## CERTIFICATE OF APPROPRIATENESS

**Property:** 1911 A Crockett St, Lot 4, Block 1, Barclay Estates Subdivision. The property is a vacant interior lot, subdivided into two lots, Lot A measuring 2,604 square feet (42' x 62') and the Lot B measuring 1,596 square feet (42' x 38').

**Proposal:** New Construction – Residence

Construct a two and a half-story 2,640 square foot residence and attached garage.

**NORTH ELEVATION – FRONT FACING CROCKETT STREET**

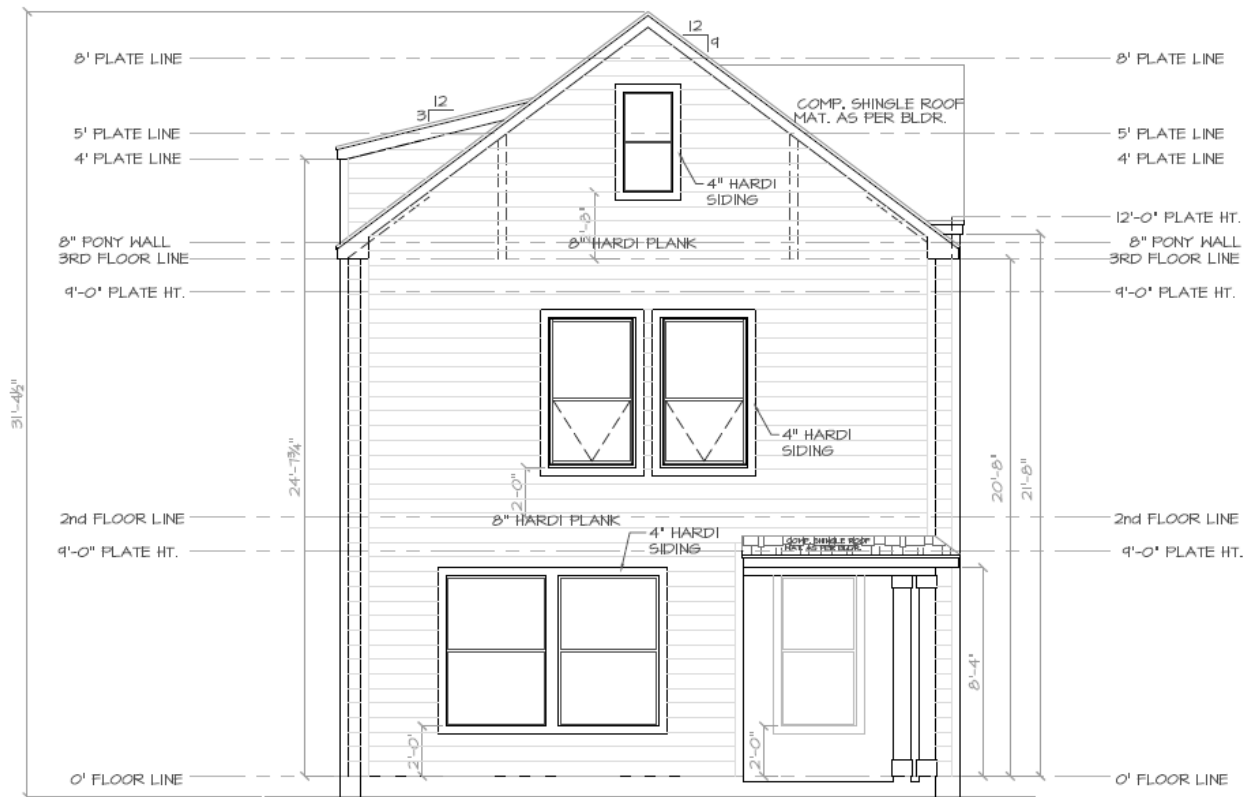
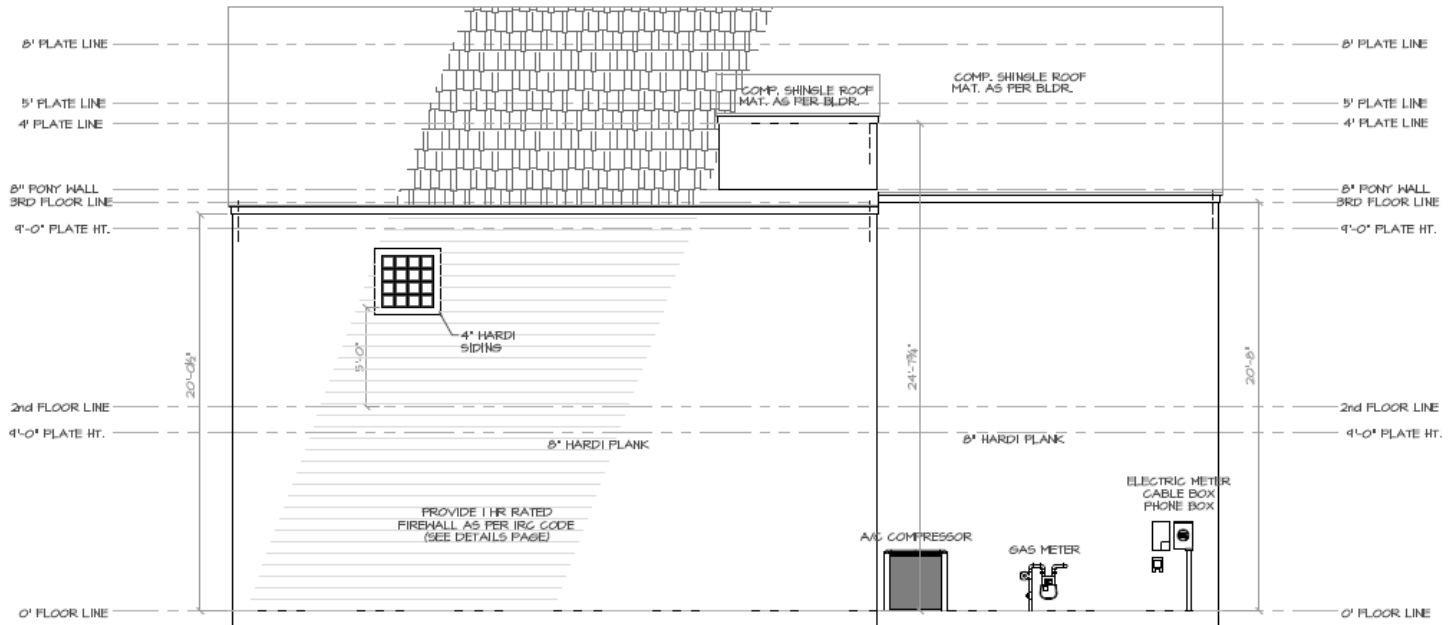
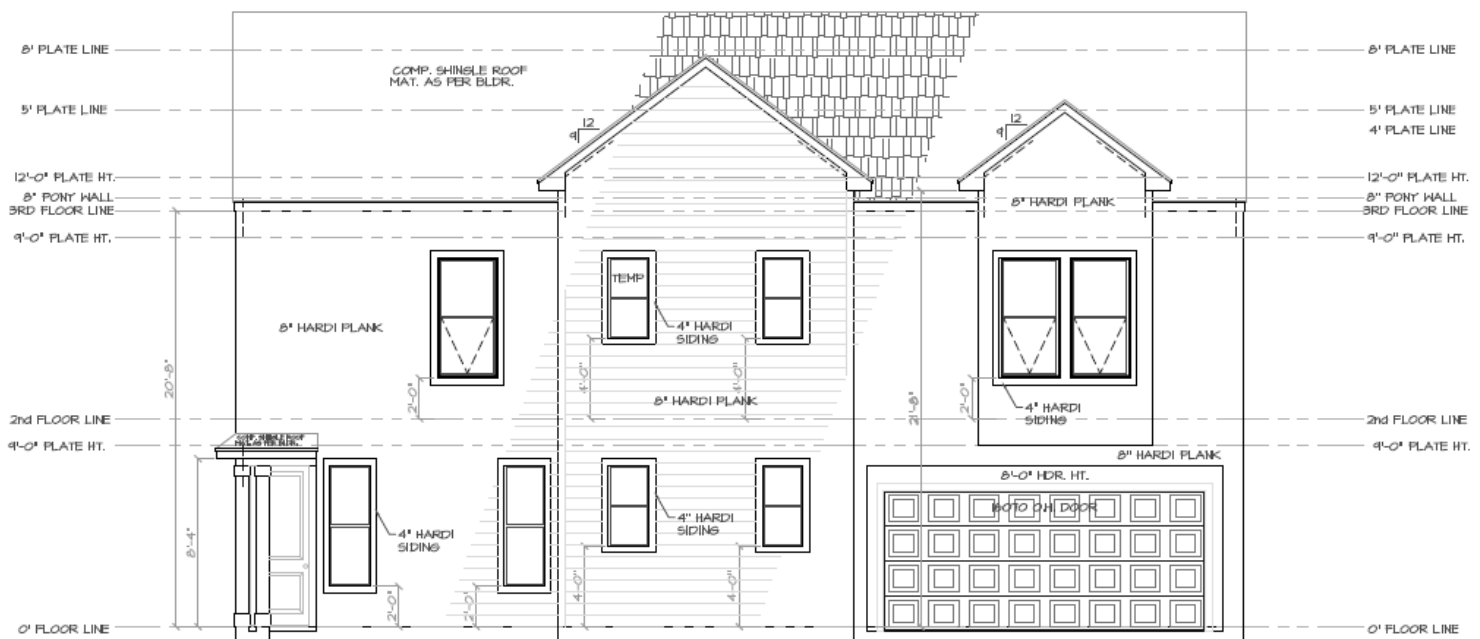
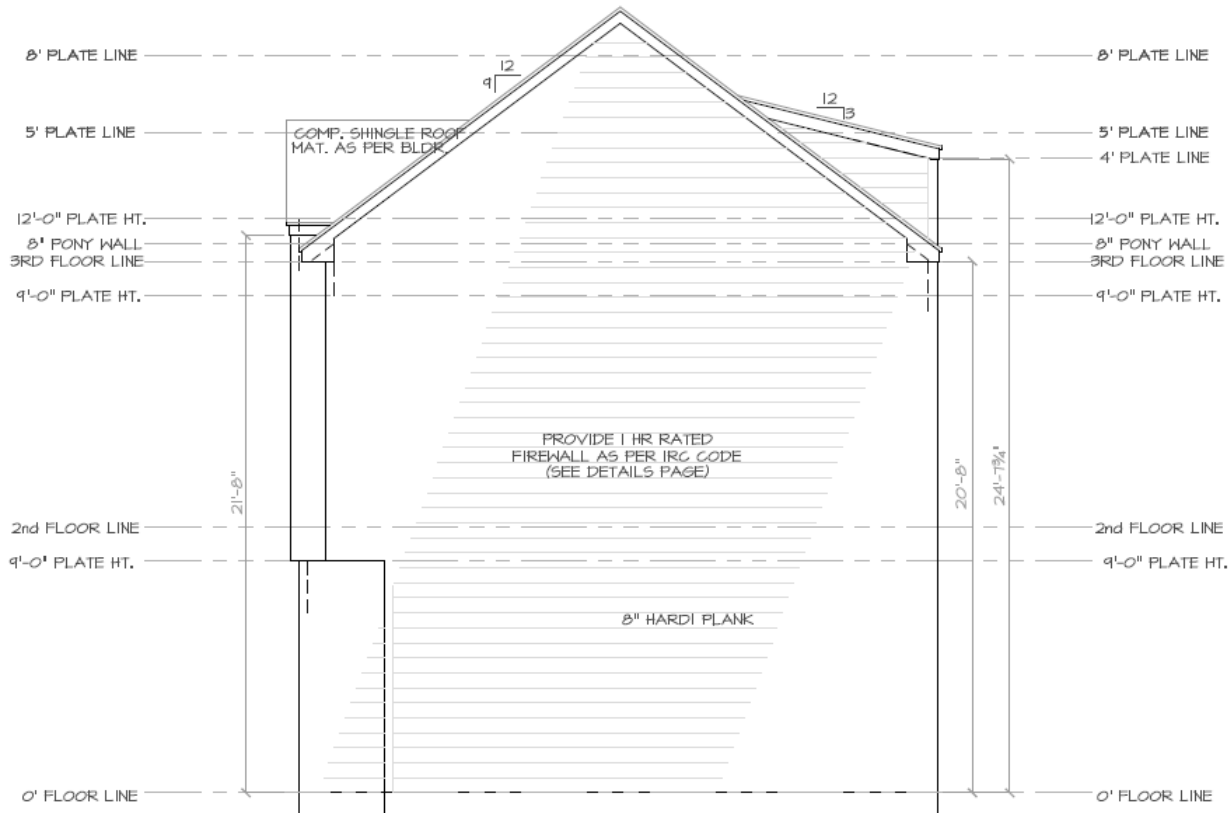
- 8" horizontal lap cementitious siding is not an appropriate feature within the context area. Smooth-finish 4" reveal horizontal lap cementitious siding would be a more appropriate siding option.*

- 3.1. 8" hardie plank has been specified throughout. This material is cheap-looking and not in keeping with the historic structures in the District. 4" plank should be used instead. Additionally, the texture of the planks to be used is not noted; flat-texture planks should be used.
- 3.2. Glass block has been specified in all of the designs. This material does not seem appropriate for a historic district.
- 3.3. Many of the windows in the designs are large, single-pane fixed windows. This type of window does not seem appropriate to this historic district. 1-over-1 and 2-over-2 double-hung windows are the norm in this district.

SITE PLAN

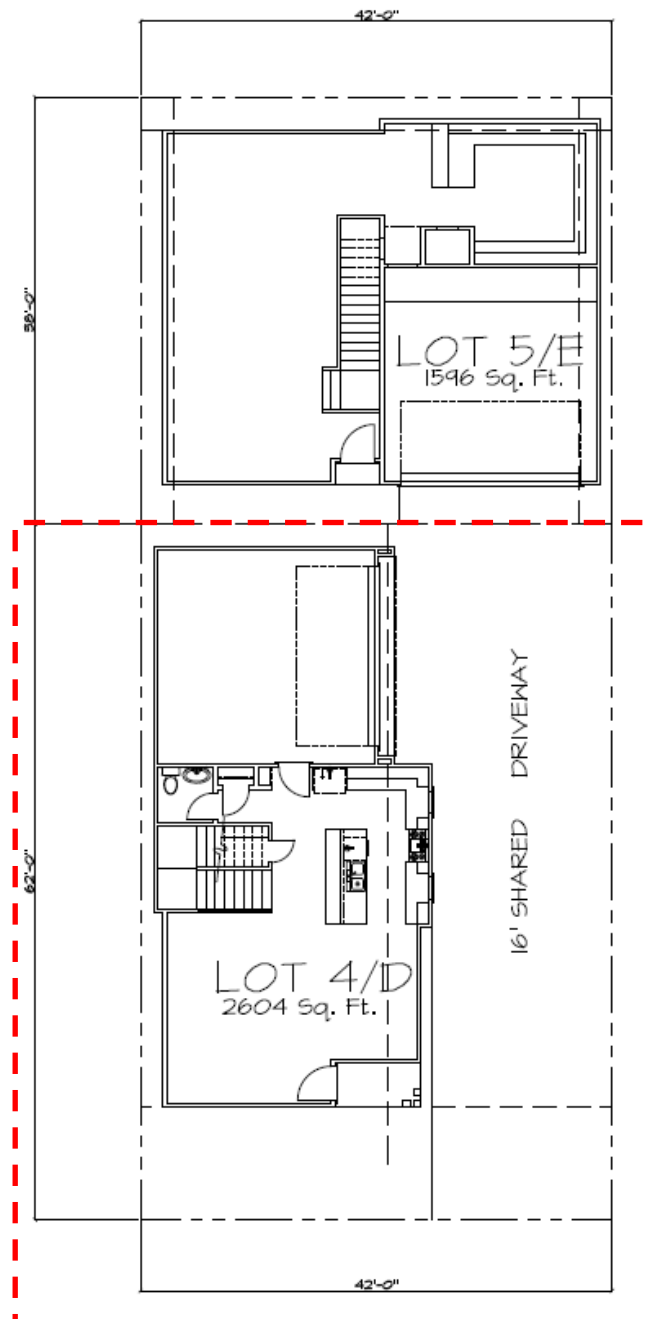
- 1.1. A site plan is required for a COA application. Each of these applications includes a drawing labeled "Site Plan". However, these purported site plans do not indicate the orientation of the proposed buildings to the surrounding streets or to each other. In addition, the elevations are listed as "left", "right", etc. instead of the usual "north", "south" etc. All this is contrary to industry standards, and makes the site plans are very difficult to decipher. This needs to be addressed in order to make the proposed plans more readily understandable.

- 1.2. Given the close proximity and interrelationships of the proposed buildings with one another, a site plan should be provided that covers all the buildings in the project so that what is being proposed can be understood.

- 1.3. With respect to the applications for 1911A and 1911B Crockett: according to the records available online, the 5,000 square foot lot in question is platted into 3 lots, so one might have expected to see applications for 1911A, 1911B and 1911C. However, no COA application for 1911C appears to have been made. Are we to understand that the 5,000 square foot lot is being replatted into two instead of three, i.e., that 1911A and 1911B are going to take up the full 5,000 square feet? This is another point that the site plan should have made clear, but doesn't.

- 1.4. The historic/contributing structure at 1907 Crockett is known to encroach on its neighbor to the west (1913 Crockett). This encroachment is not shown on the site plan. This omission is significant, since it affects the actual distance that will separate the new structure at 1913 from the existing one at 1907.

- 1.5. A 10' setback from the street is noted. This is out of character for the District, where setbacks of 15 feet or more are prevalent on contributing structures. Is this permissible?
